DEVELOPMENT REVIEW BOARD
SUPPLEMENTAL SUBMITTAL

PROJECT NO. 2022-006547

DESCRIPTION: DRB - Site planning 2nd resubmittal city comments response

RE: Panda Express – S8-22-D8582
10126 Coors Blvd. NW
Albuquerque, NM 87114
RE: DRB Planning Review – 2nd Resubmittal
DRB Project Number: 2022-006547
App. Number: SI-2022-00216

P1 Illuminated D/F Pylon Head on Existing Poles (Qty. 1)

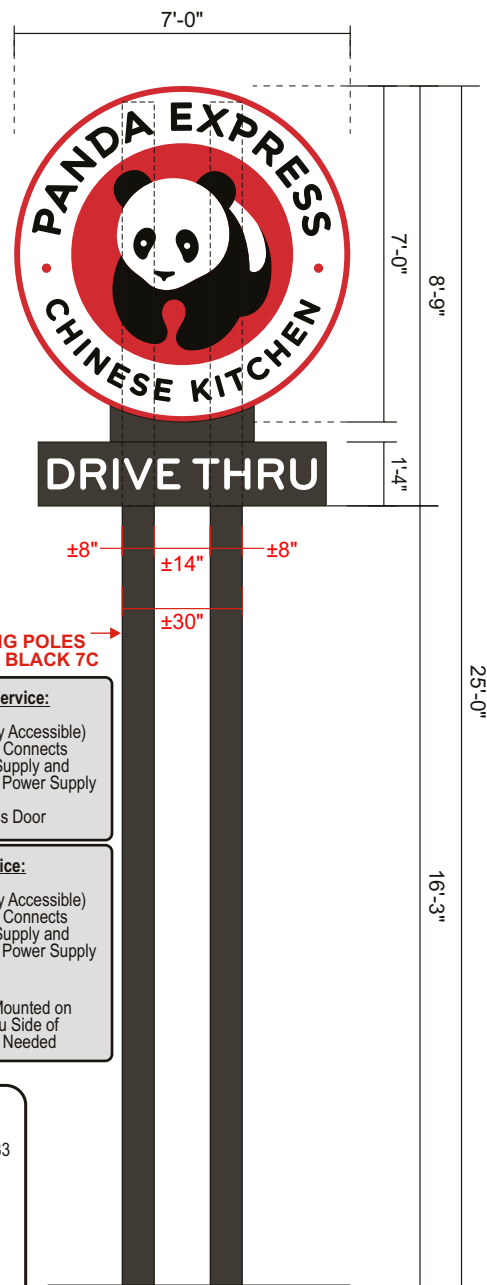
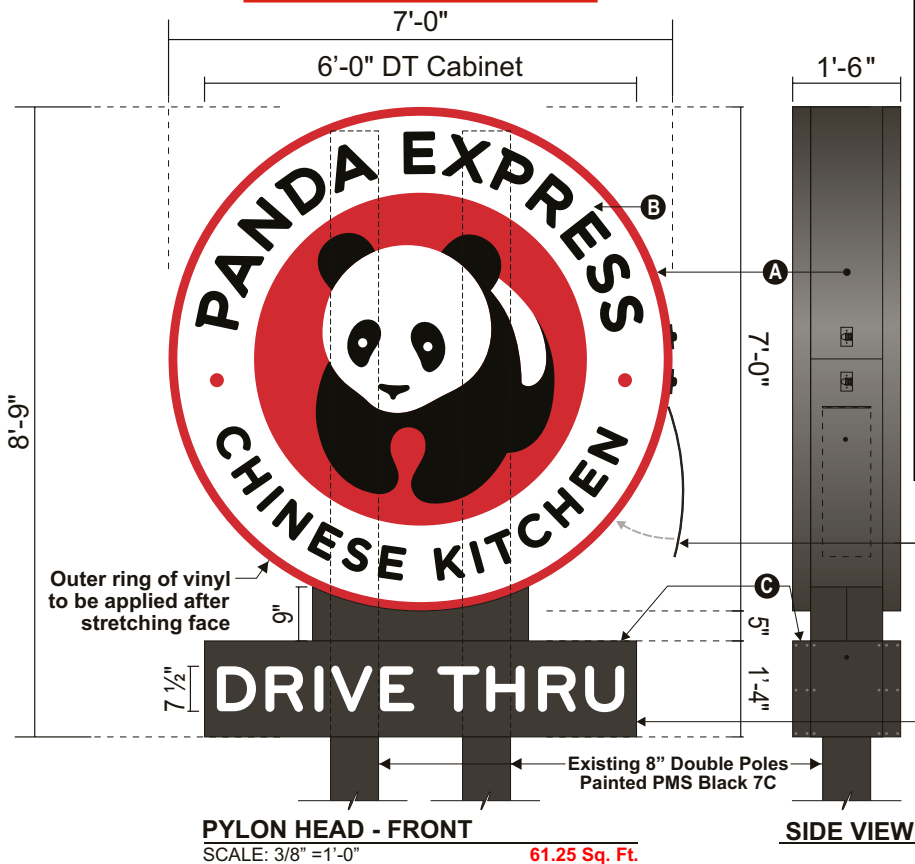
- Cannot remove existing sign structure or increase its height – you must utilize existing poles, but can modify shape of sign face, as long as you do not exceed the square foot size of the existing sign face.

- If remove entire structure, then must comply with CPO-2 limits 9 ft height and 75 sq ft size.

Response: Panda is proposing to re-use the existing poles structure but is modifying the shape of the sign cabinet and maintaining the square footage of the existing sign.

Response: Panda is proposing to utilized the existing sign structure. Refer to Proposed signage drawings.

SITE PLAN

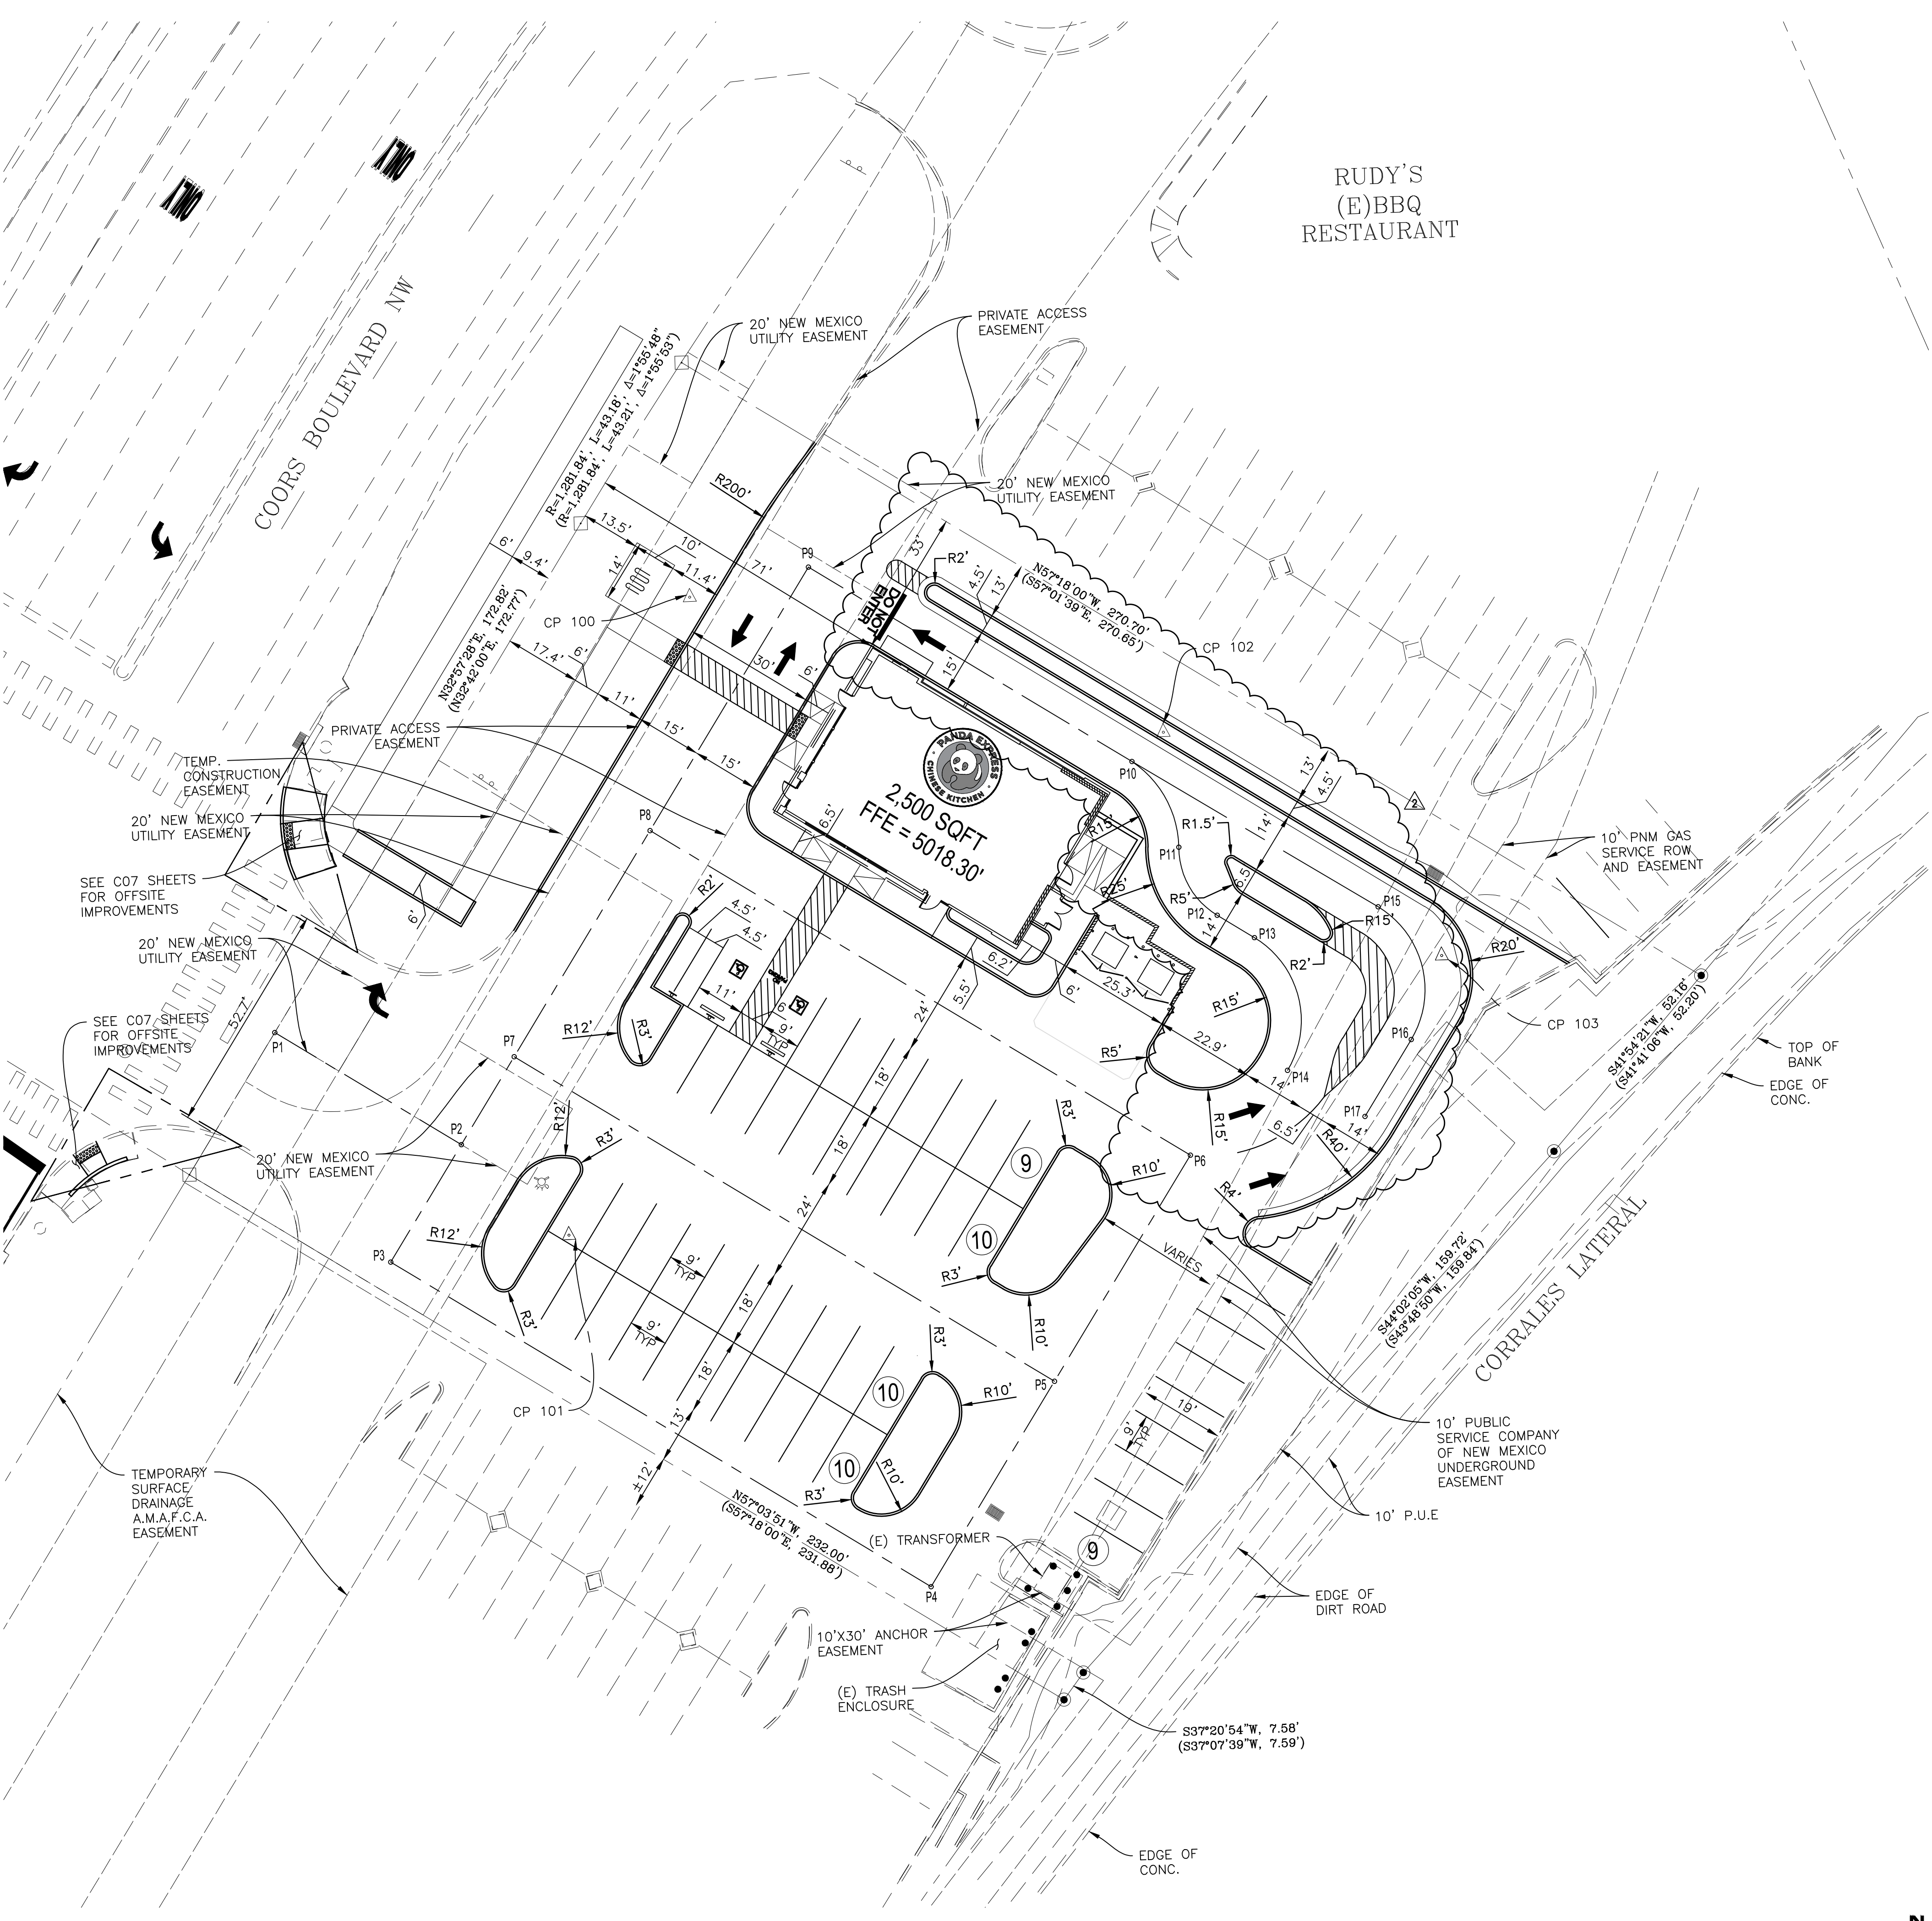
5. Along with the curb and curb ramp details provided, reference the exact details as part of the keyed notes on the site plan.

Response: Noted, see updates on sheet C03.0 and C03.1

5 ACCESSIBLE AREA AND STRIPING

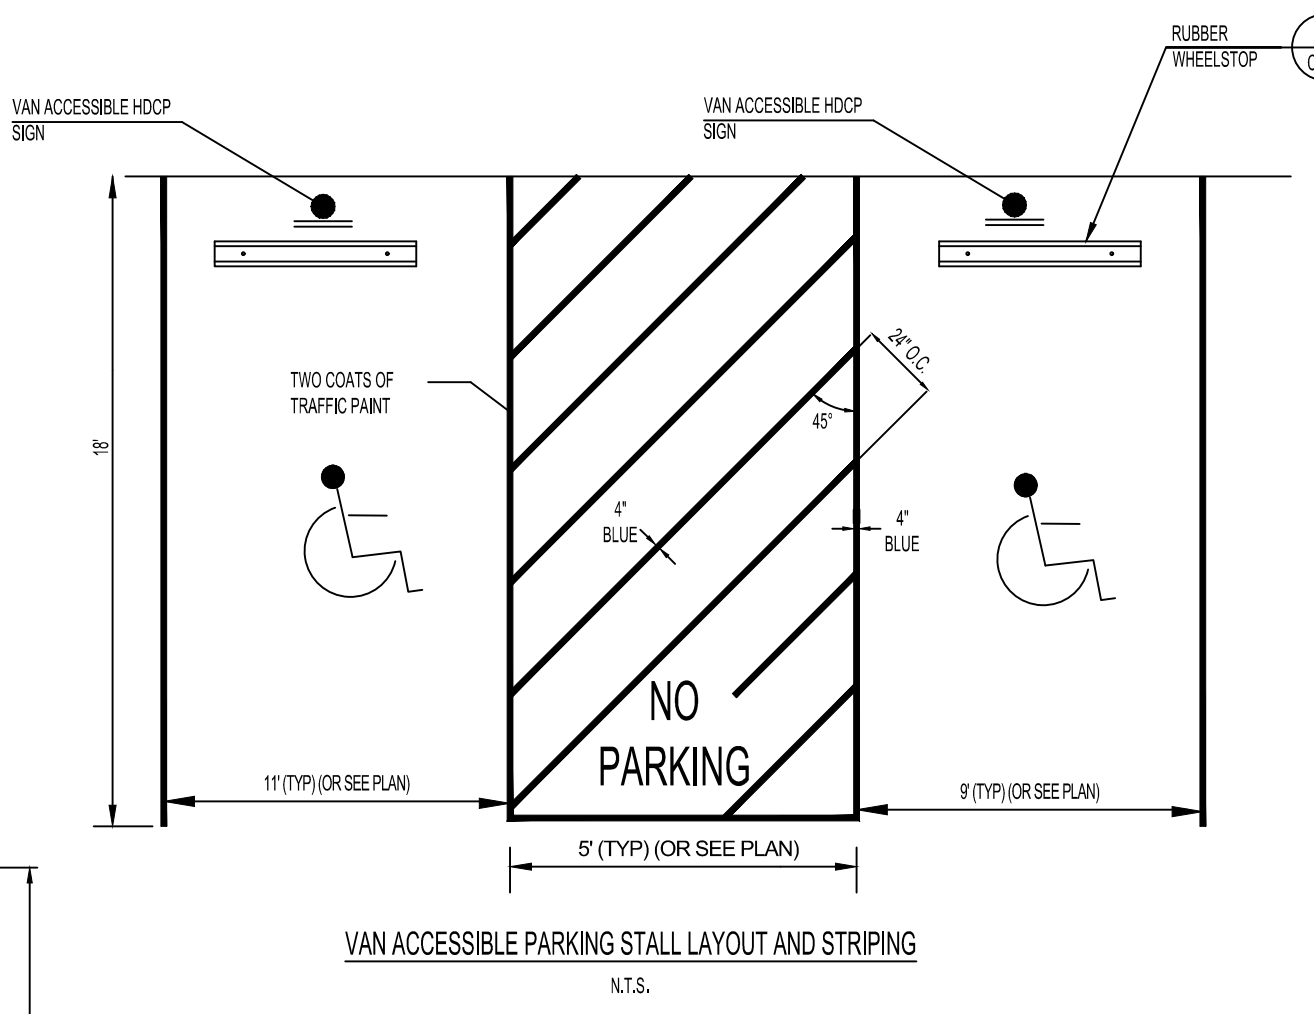
7. The ADA accessible parking sign must have the required language per 66-7-352.4C NMSA 1978 “**Violators Are Subject to a Fine and/or Towing.**” If that language is present it is not visible in the detail.

Response: Noted, see updated detail 5 on sheet C03.2

SITE PLAN 1
Scale= 1/16" = 1'-0" A-100

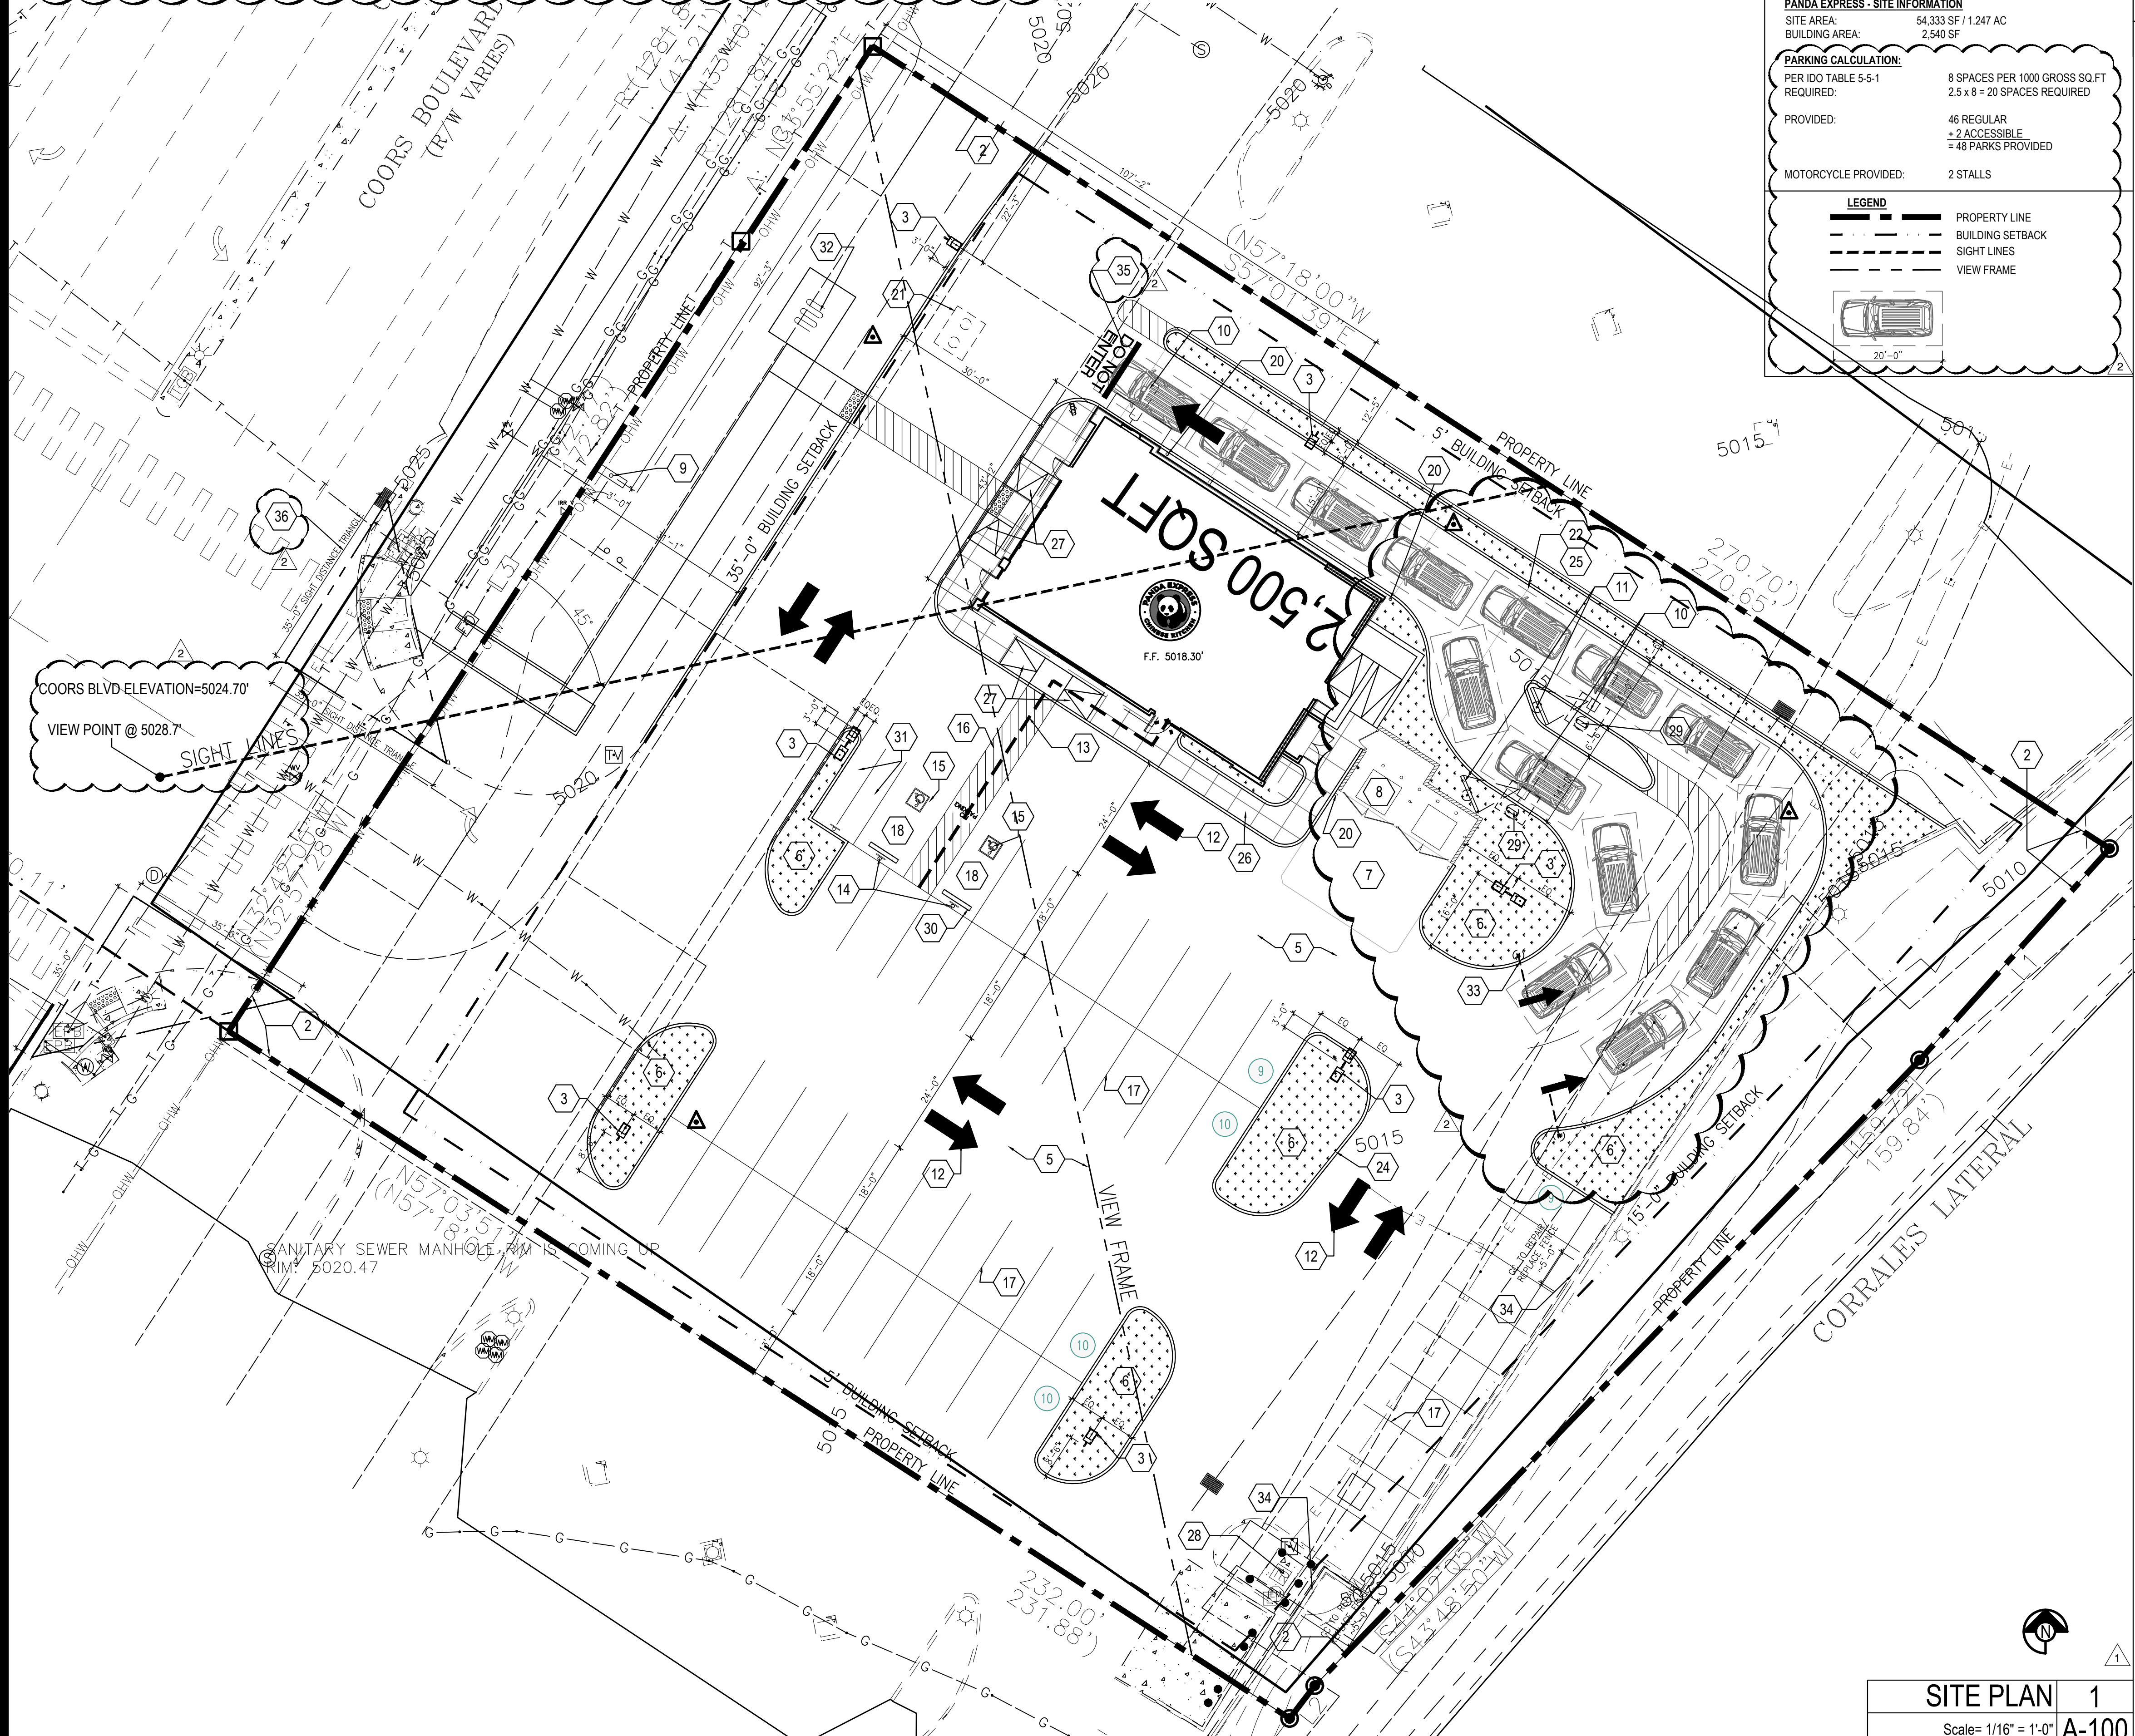
- Updated 4/4/22 – The parcel lies within the Coors Boulevard View Protection Overlay. The construction of a new building in a new location triggers the View Protection Analysis requirements of 3-6(D)(5)(b) Building Structure height, Bulk and Massing (View Plan) wherein no more than 1/3 of the height of buildings and structures may penetrate the view plan. The second test is 5-6(D)(5)(c) Building and Structure Bulk (View Frame). No more than 50% of the area in the view frame can be obscured by the bulk of the building and no portion of the building shall extend above the ridgeline of the Sandia mountains (Full detail in the IDO is given for this analysis)

6. For the drive-thru, one-way, “Do Not Enter” signage, and pavement arrows shall be called out on the site plan.

9. Provide clear intersection sight distance triangle at the entrance. Reflect these on the site plan and landscaping plan. Provide standard note on landscaping height requirements within this sight triangle. ("Landscaping, fencing and signing will not interfere with clear sight requirements. Therefore, signs, walls, trees, and shrubbery between 3 and 8 feet tall (as measured from the gutter pan) will not be acceptable in the clear sight triangle.")

Response: Drawings have been updated refer detail 1, 3 and 13/A-100 for overlay analysis of overlay.

Response: Refer to sheet A-100 and civils drawings for revised site plan. Sheet A-100 shows the required continuous queuing 12 spaces for drive-through vehicle stacking.

Response: Refer to sheet A-100 calculation have been updated parking calculations.

Response: Noted, see sheet C03.0, A-100 and L-1 for sight triangles and note.
